From: Sent: To: Subject: Lindsey Ozbolt Monday, February 6, 2017 1:17 PM marywictor@comcast.net Re: Spelling Correction: Zaccuse to Zackuse Creek. King County ELSTrail SSDP2016-00415

Thank you for contacting the City of Sammamish regarding the current Shoreline Substantial Development Permit Application for East Lake Sammamish Trail Segment 2B (SSDP2016-00415).

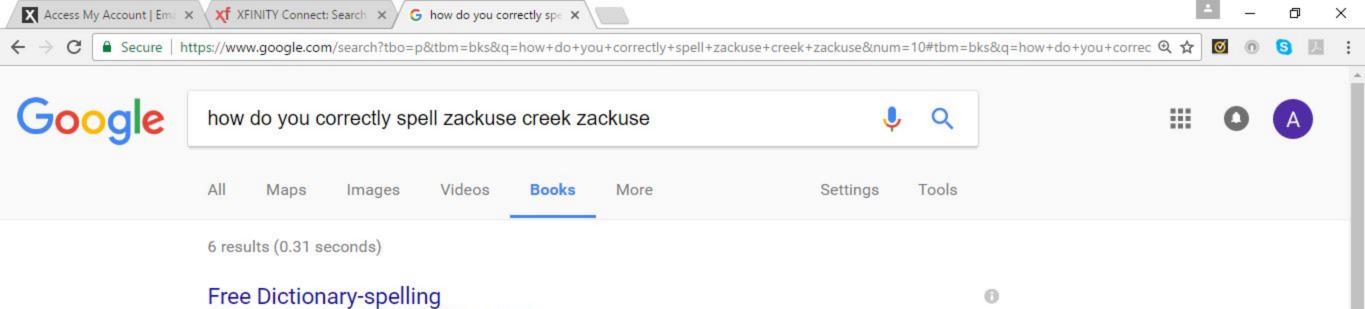
All the Creek references to Zackuse Creek in the 60% design spell the name wrong as "Zaccuse". See two attachments for other references.

Zaccuse should be corrected to Zackuse Creek in all instances pages EX17, AL29, FP5, FP6, and LA17 which I found via text searches of the .pdf
